PRODUCT CHANGE NOTICE

1. TITLE IRHYS67230CM SOA Characteristics		2. DOCUMENT NUMBER FV5-C-23-0003
3. DATE October 14, 2022		
4. MANUFACTURER AND ADDRESS International Rectifier HiRel Products, Inc 205 Crawford Street Leominster, MA 01453		5. MANUFACTURER PART NUMBER See below for IR Part Numbers
		6. BASE PART NA
		7. NATIONAL STOCK NUMBER (NSN) NA
8. CAGE 69210	9. EFFECTIVE DATE October 14, 2022	10. GOVERNMENT NUMBER NA
11. POINT OF CONTACT Manufacturer's Representative or Account Specialist (978) 534-5776		12. DRAWING NUMBER NA
		13. SPECIFICATION NUMBER MIL-PRF-19500/755

IRHYS67230CM (JANSR2N7592T3)
 200V, 16A, N-Channel, TID Hardened MOSFET in a low-ohmic TO-257AA package

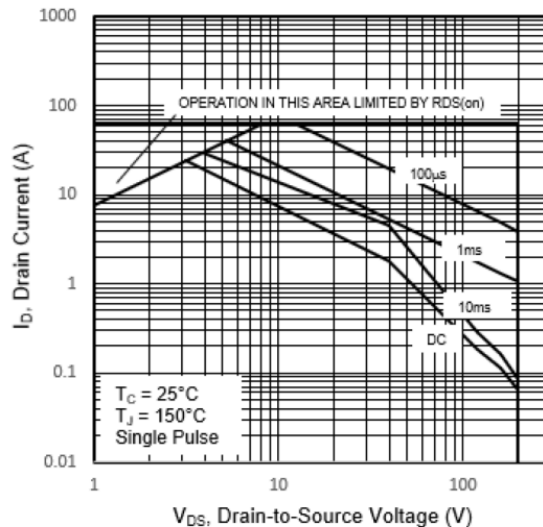
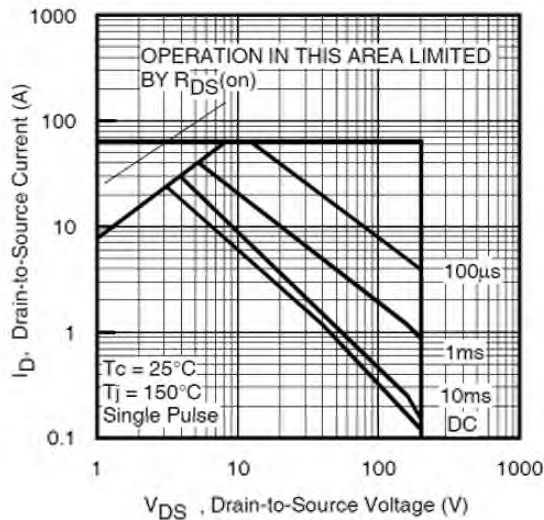
This GIDEP PCN is to announce specifications change/update in the Maximum Safe Operating Area (SOA) characteristics for the following International Rectifier Part No. Note that this change is related to part specification only, and not due to a die physical change.

Datasheet updated with new SOA characteristics including DC curve.
